Tyler Grange Comments 15.07.2020

Application No: V/20/87717

Address: Land West of, Horton Heath

Landscape Officer Comments 15/05/20

Project	Horton Heath
Drawing Title	Site Specific Landscape Character Areas
Scale	Not to Scale
Drawing No.	11705/P23
Date	July 2020
Checked	KL/RP

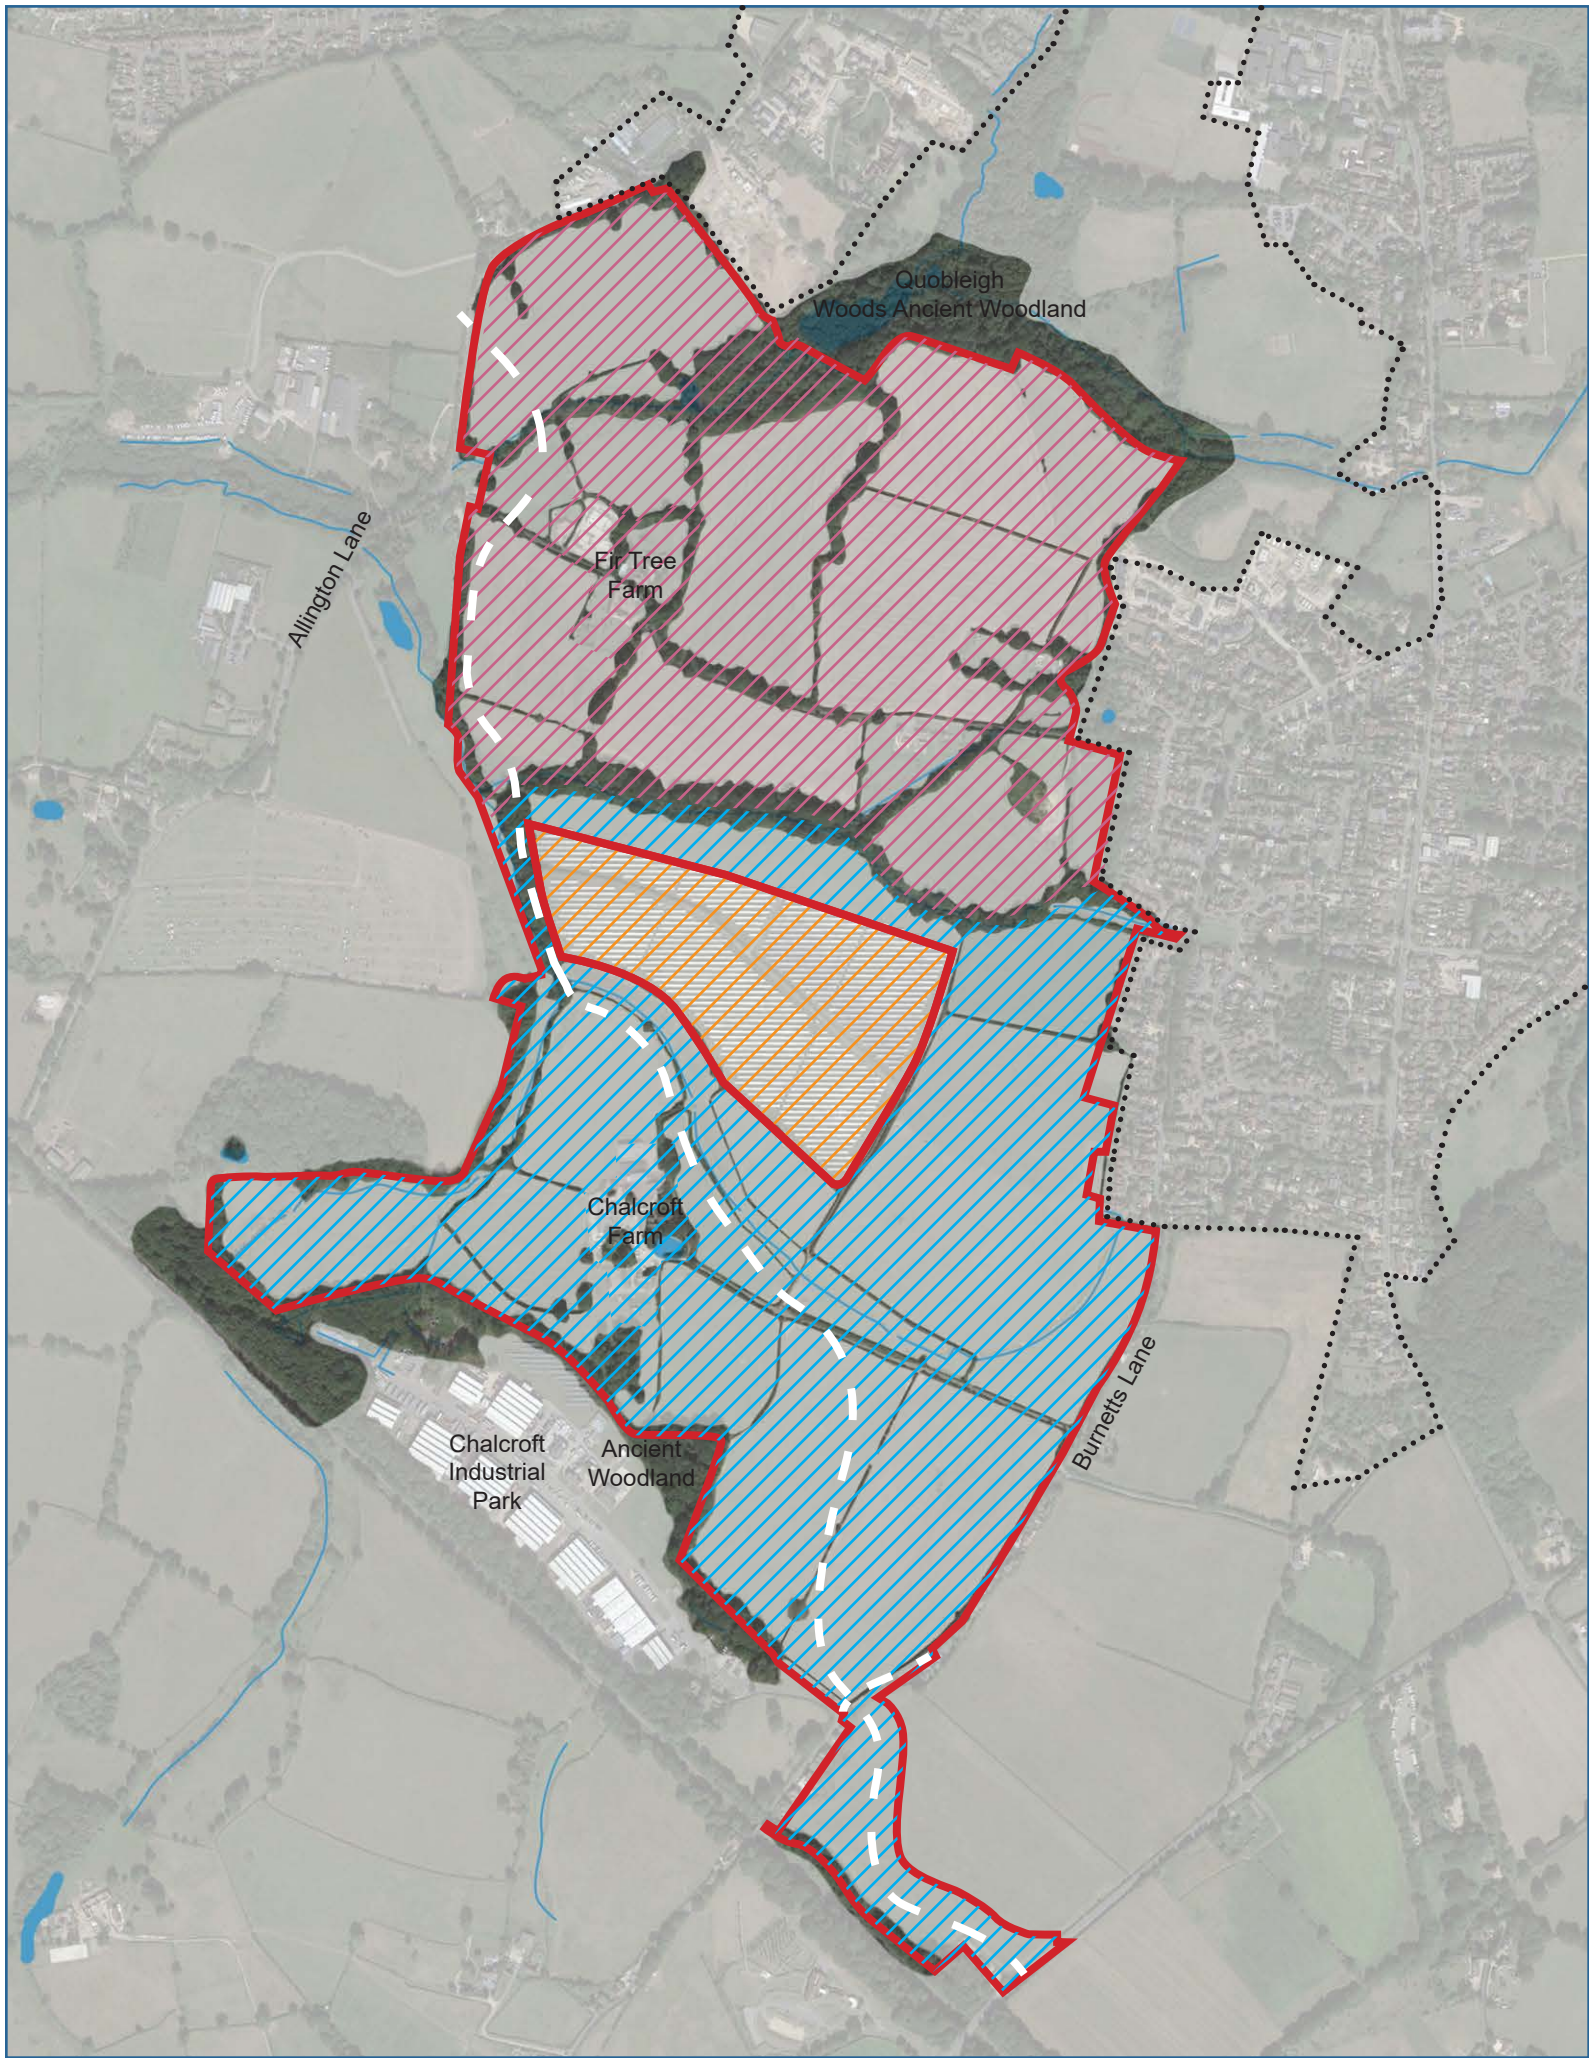
b) Discrete landscape elements have been identified as Landscape Receptors. It would be helpful to also look at how this can be framed from a holistic Green Infrastructure perspective. Therefore not only looking at the effects on the individual elements but also packaged as GI ‘typologies’ or systems. For example; a hedge with some mature tree in it and wildflower meadow at its base, or perhaps with a drainage ditch alongside, is a richer feature in landscape terms with a higher intrinsic value than assessing at a hedge in isolation. Some thought should be given to how these can be defined and assessed this way.

Action: Review landscape receptors and provide criteria for GI typologies or systems.

The landscape receptors will be updated to include GI Typologies. The key Landscape Character Areas which will be assessed are identified on Plan **11705/P23**:

- Northern Quobleigh Character Area
- Southern Chalcroft Character Area

Within these key character areas are a number of 'GI Typologies' as identified on Plan **11705/P23**.
